**WEST AVE. ELEVATED STORAGE TANK
PAINTING AND REHABILITATION PROJECT
SAWS Job No. 18-0110
SAWS Solicitation No. B-20-008-SM**

**ADDENDUM 1
7/27/2020**

CS-102

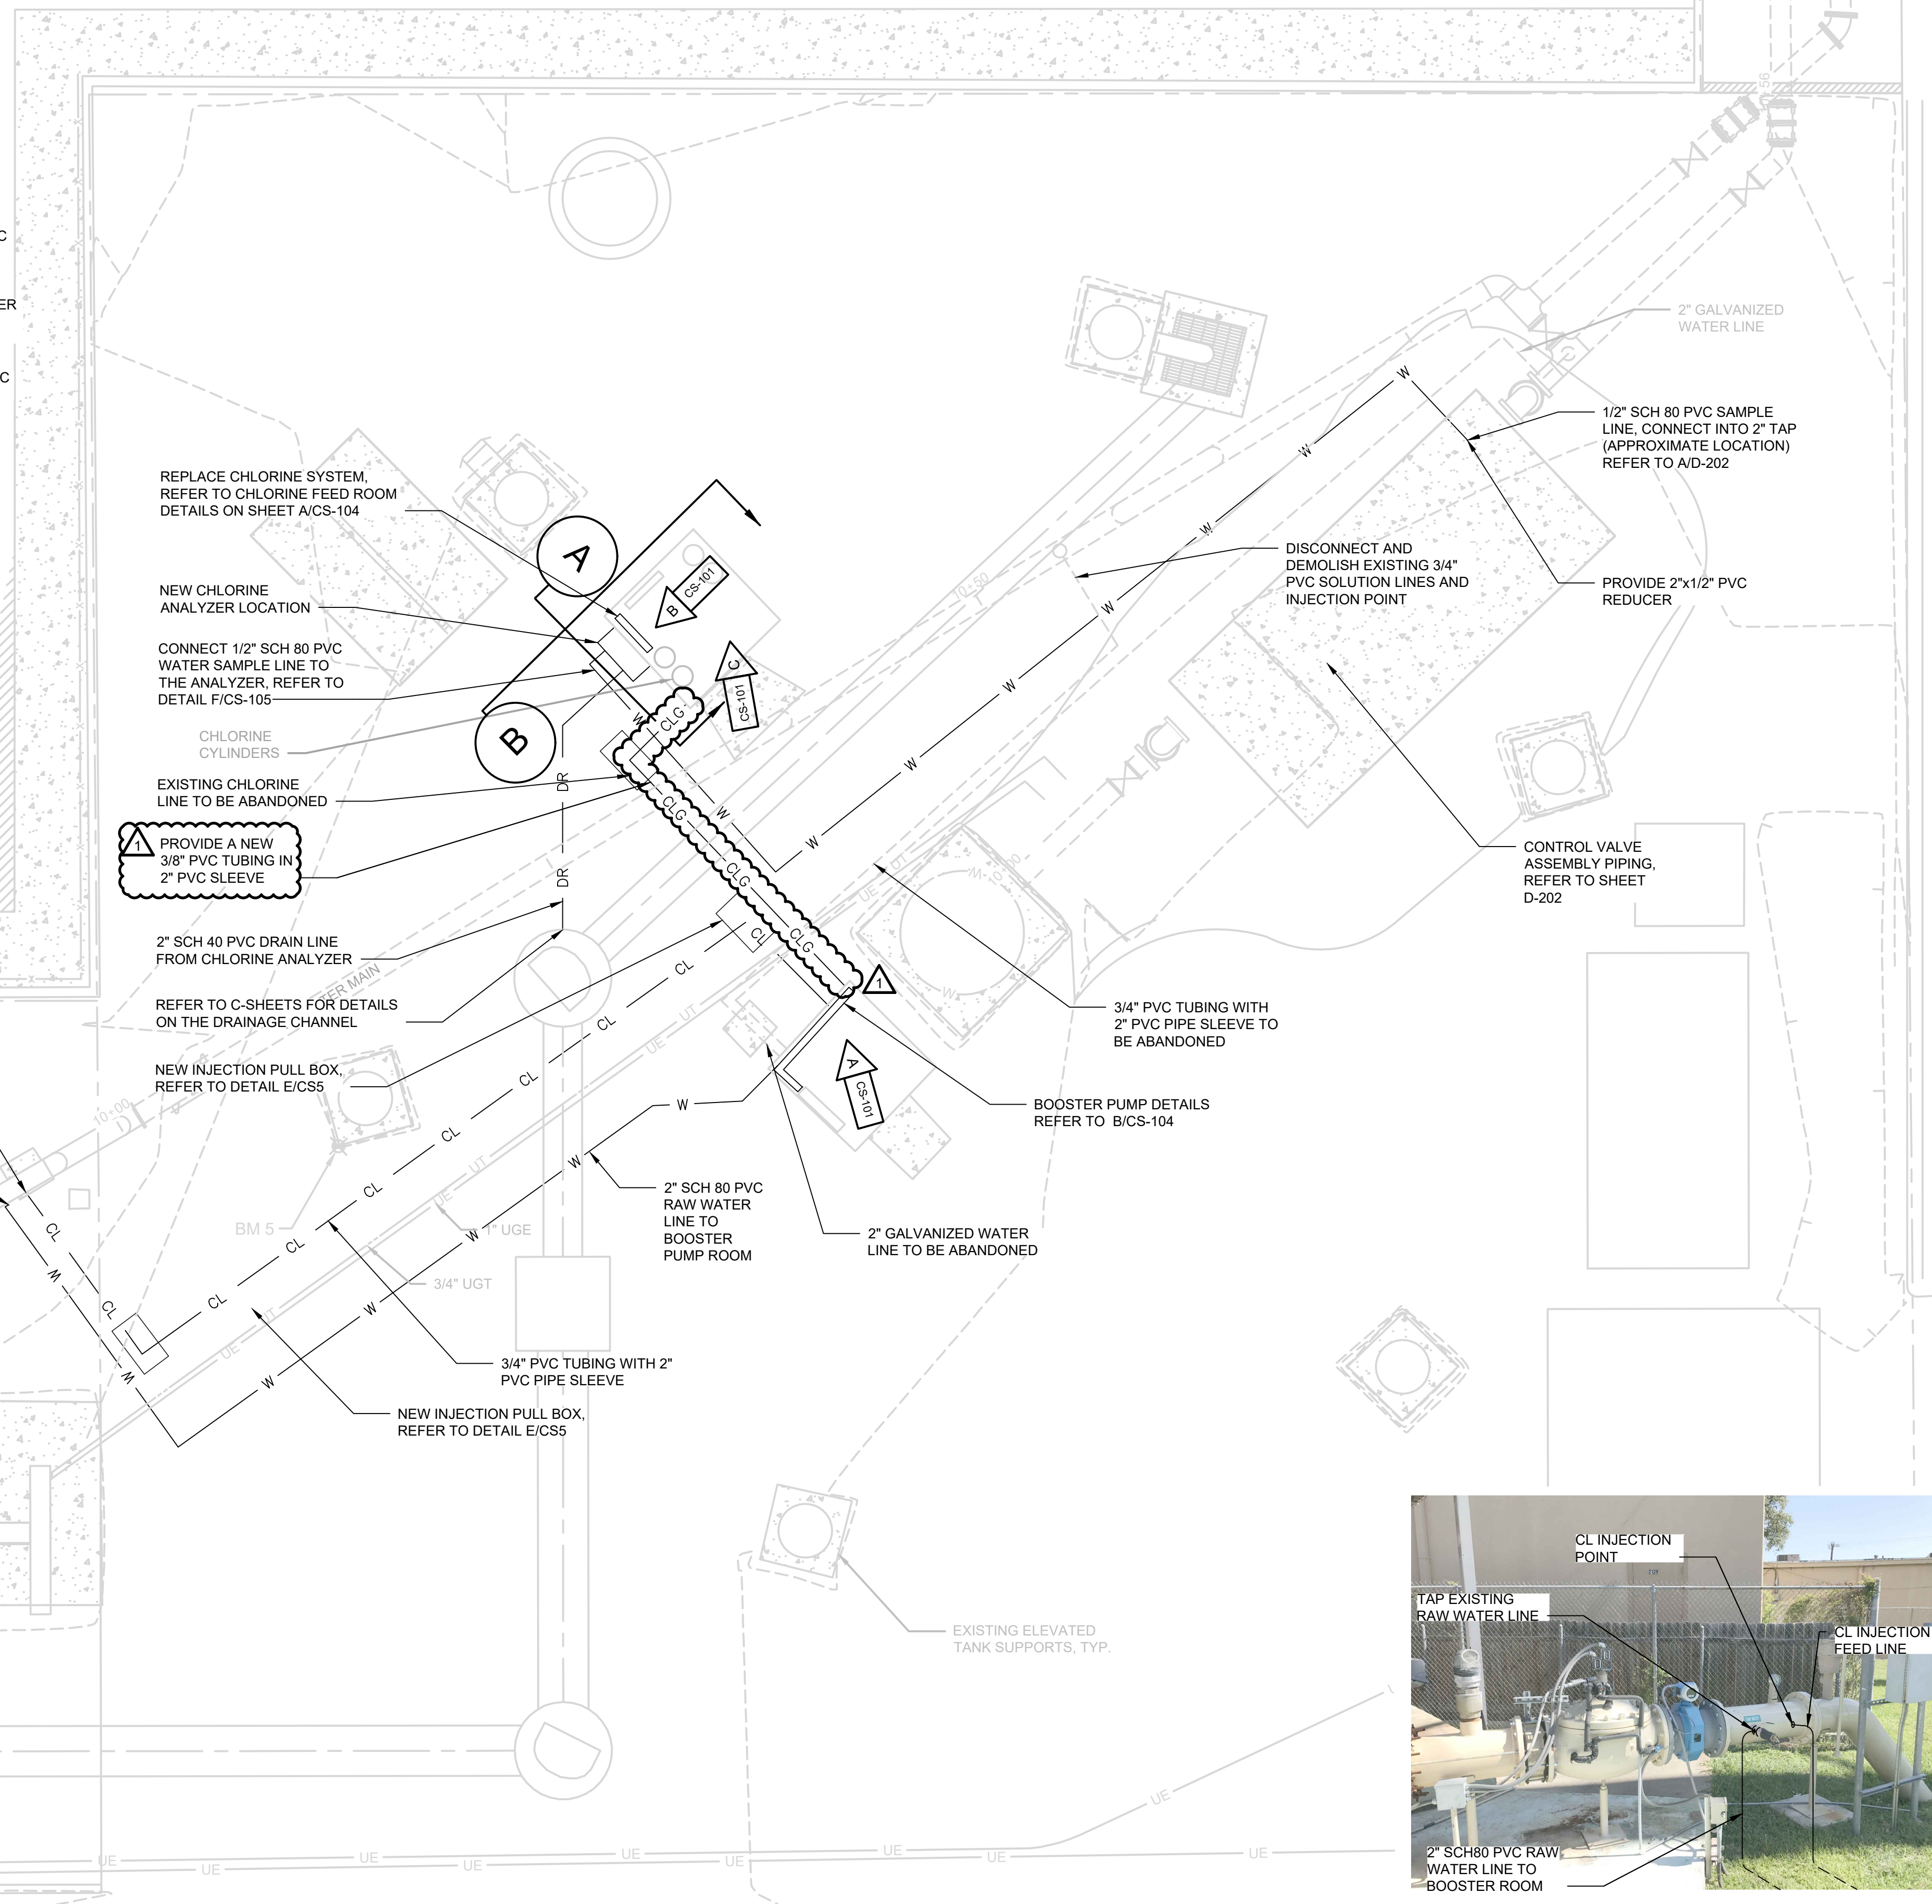
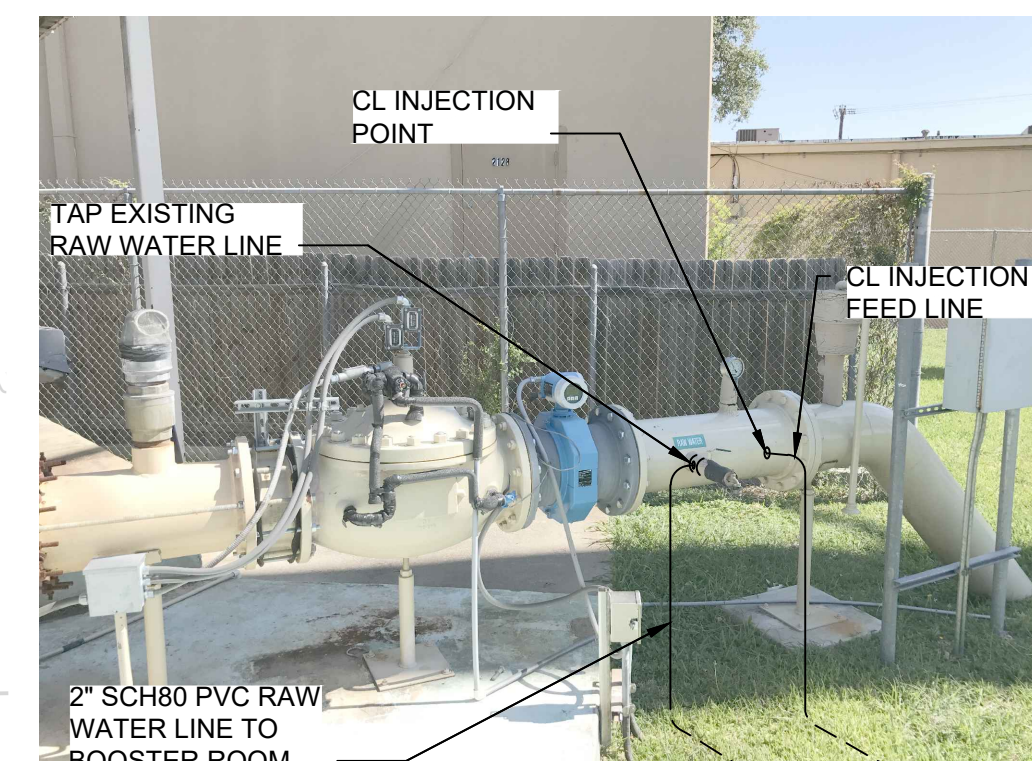
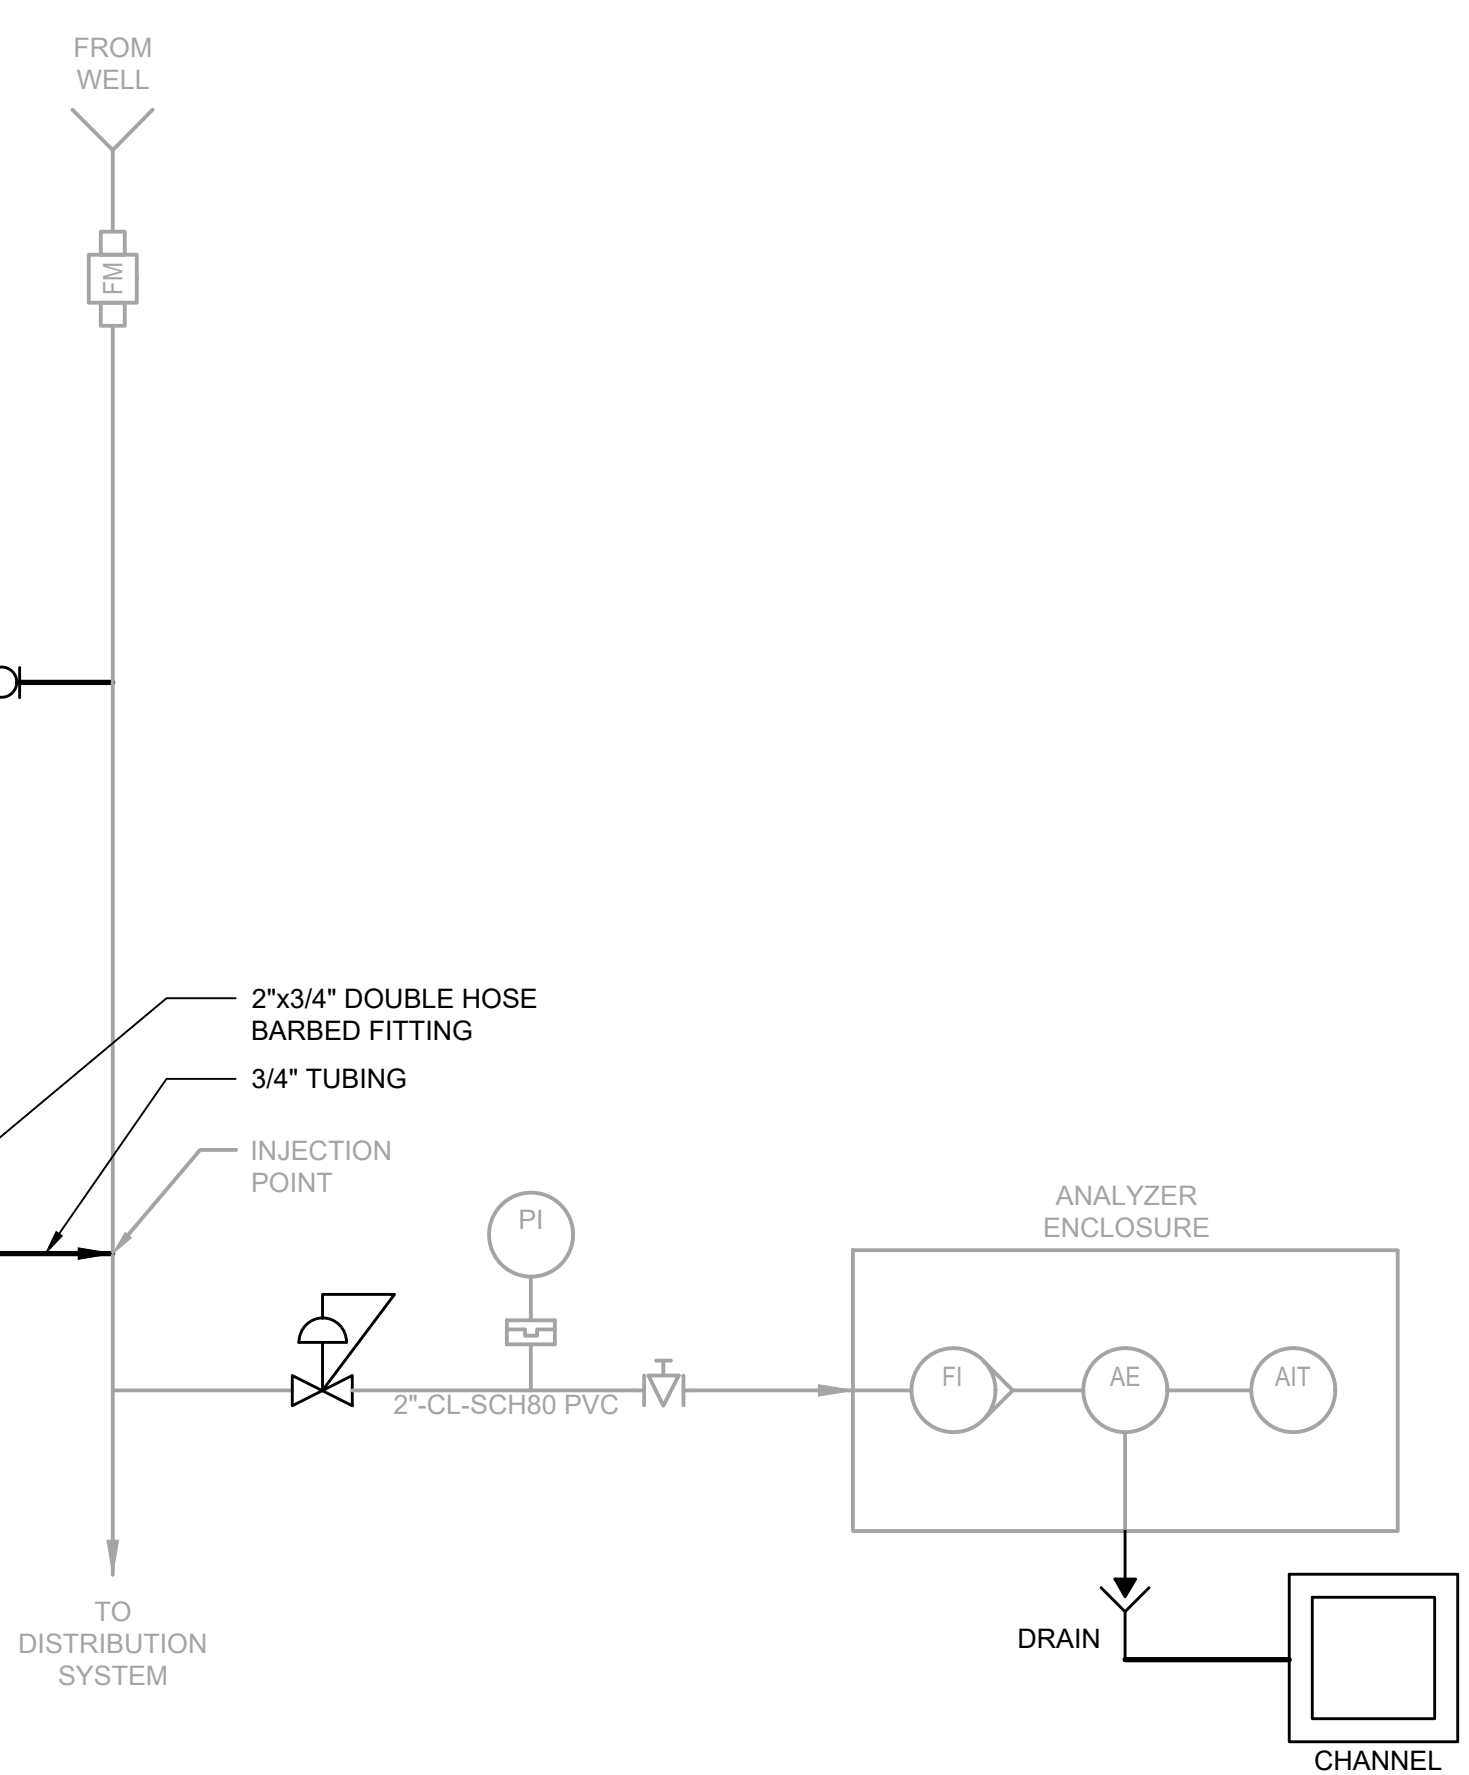
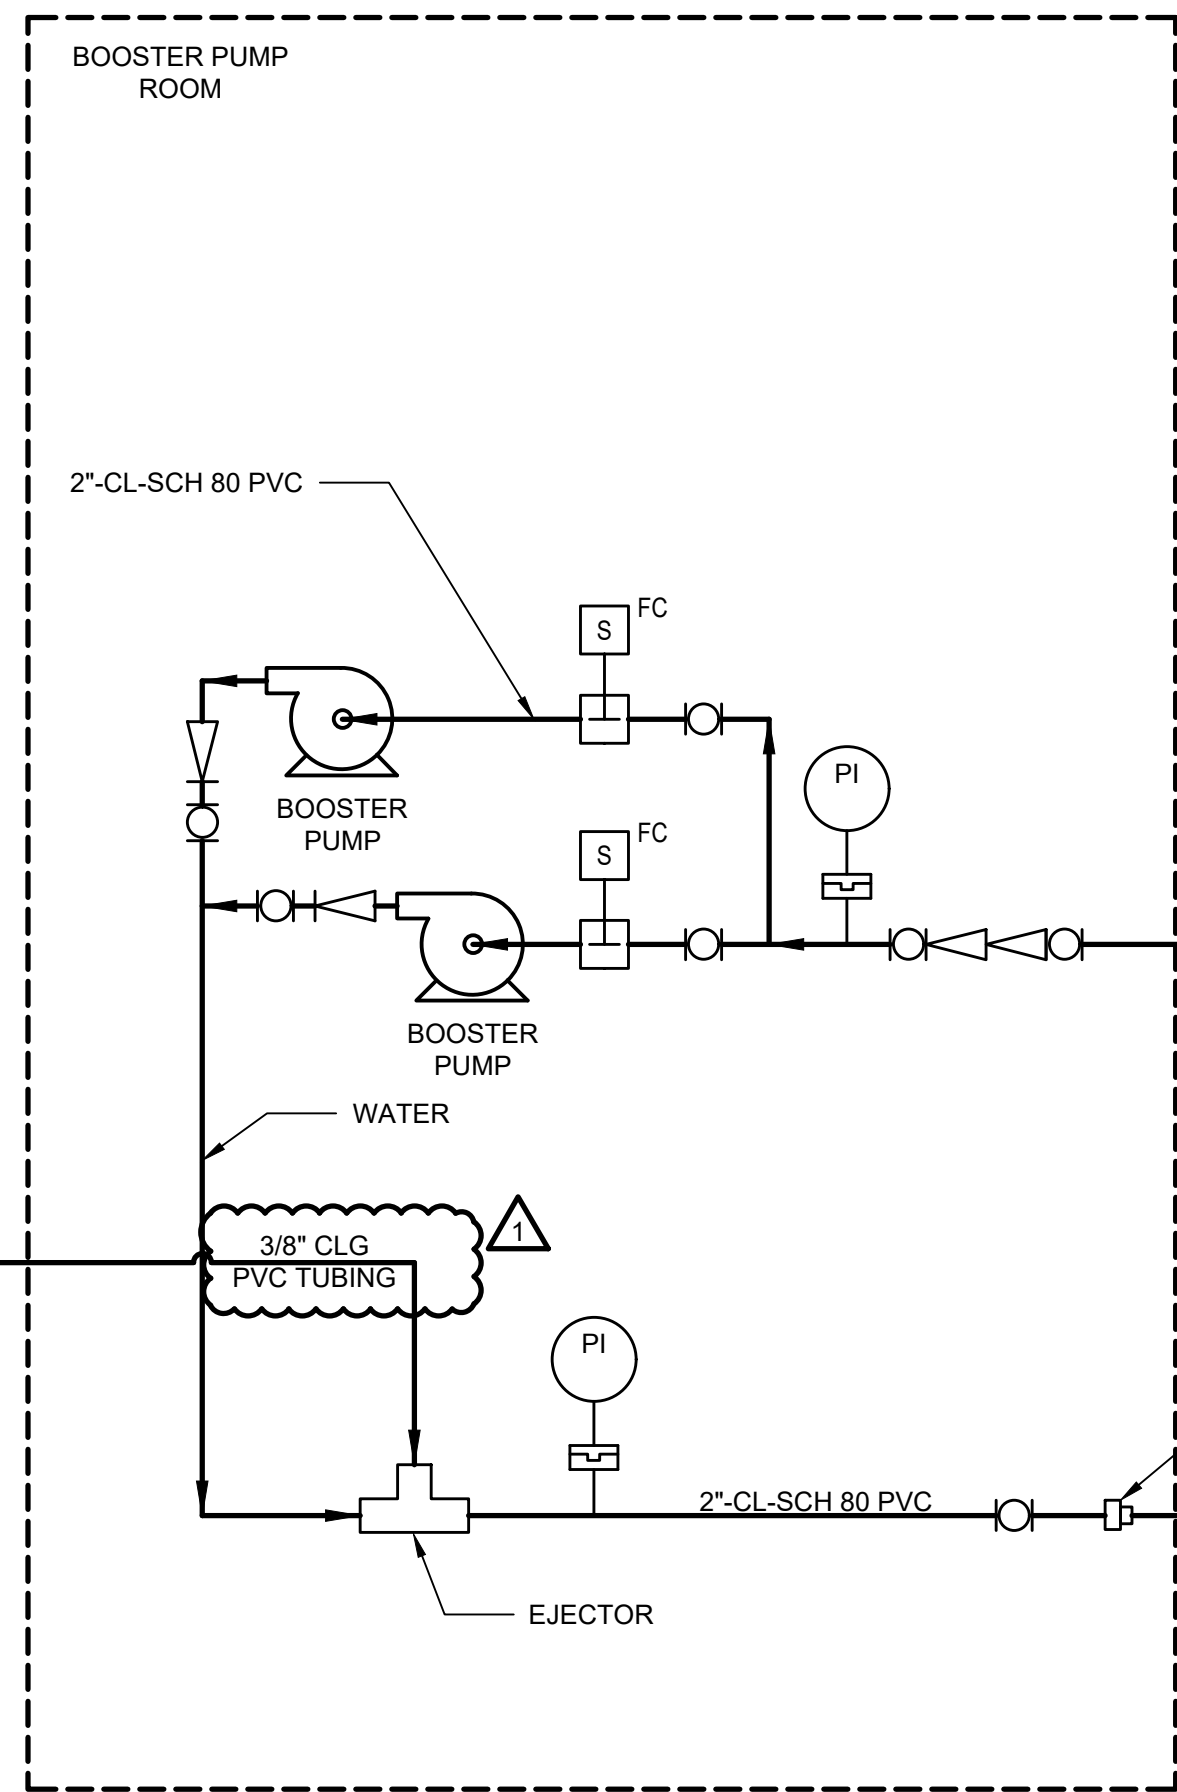
- 1. DELETE drawings CS-102, CS-103 and CS-104 and REPLACE with the sheets attached in this Addendum.

MARK	DATE	DESCRIPTION	BY
1	07/17/20	PER ADDENDUM #1	MK
